SERVICE BULLETIN

Change of measurement method from cylinder head temperature to coolant temperature for ROTAX® Engine Type 912 and 914 (Series)

ATA System: 75-00-00 Cool system

MANDATORY

Fig. 1

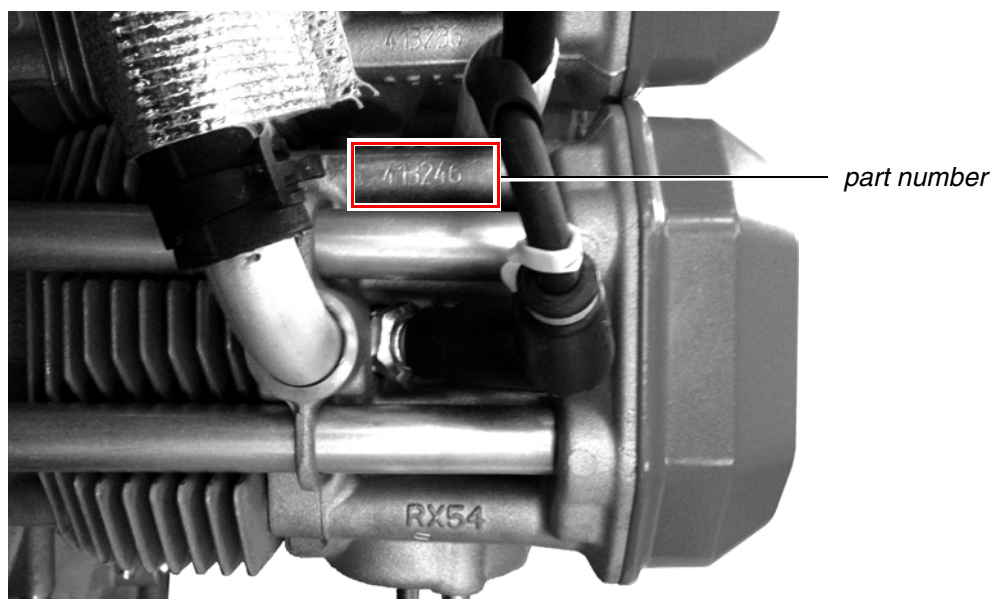
Step	Procedure
1	Check the engine serial number S/N, if the aircraft is affected by this SB.
2	Check of maintenance documentation if a repair or maintenance was performed on one of the cylinder heads.
3	Check the part numbers of the cylinder heads. See Fig. 1.
4	Check of the cockpit (indicating instruments) or the aircraft-specific manuals or consultation with the aircraft manufacturer or its service facilities if the coolant temperature or cylinder head temperature is displayed.
5	The measurement position naming in the indicating instrument or the operating limit must be amended or corrected in consultation with the aircraft manufacturer, if necessary. See section 3.1.1)

Fig. 2

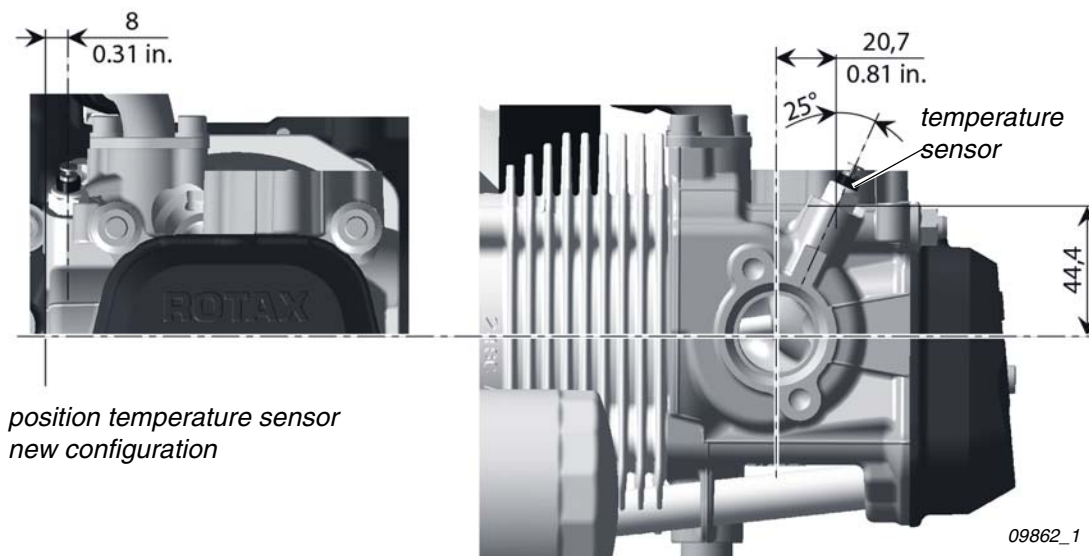
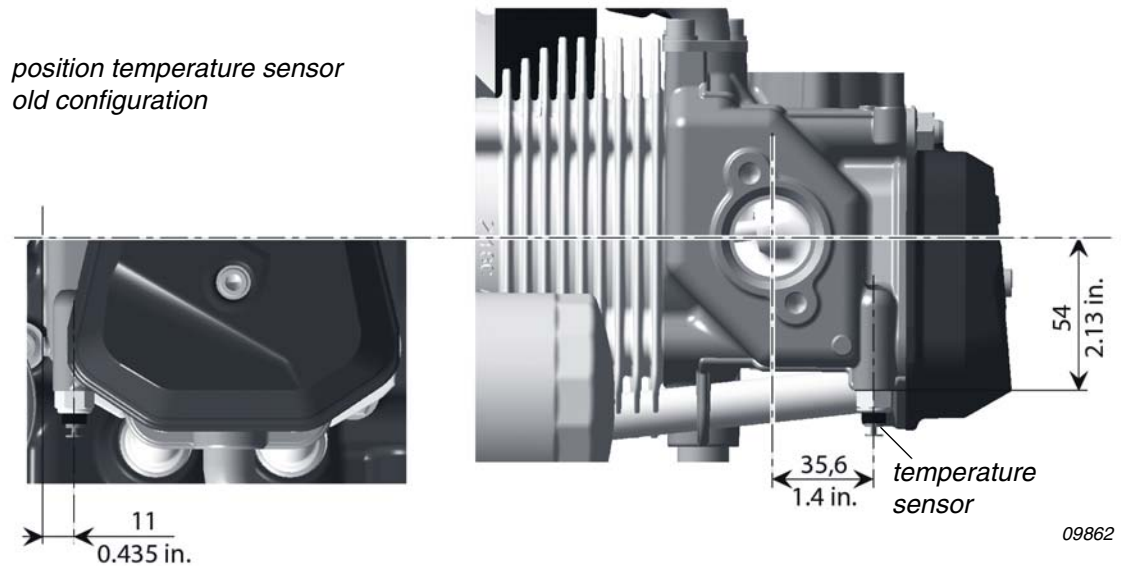
NOTE: Identifying of new cylinder heads: The electrical connection of the temperature sensor is pointing upwards. New configuration see [Fig. 2](#). Old configuration see [Fig. 3](#).

In the course of continuous development and standardization with ROTAX® 912 i Series, new cylinder heads with modifications in its mold have been introduced. Due to these changes the coolant temperature instead of the cylinder head temperature in the aluminium will be displayed. Check the temperature limit for the new positioned measuring point of the cylinder head displayed in the cockpit and if necessary correct its naming (measuring position) and limit. See chapter 3.1.1.

Regarding change of temperature sensor position, see Fig. 2 and Fig. 3.

It is NOT mandatory to retrofit engines with the old cylinder heads. The different versions of the cylinder heads can be mixed installed, but make sure, if and at which position the cylinder head temperature and coolant temperature is measured. This also defines the naming of the indicating instrument with the appropriate temperature limit.

Coolant temperature limit for measuring point in the cylinder head (new configuration)	Engine type
maximum 120 °C (248 °F)	912 A/F/S
	914 F
Permanent monitoring of coolant temperature is necessary
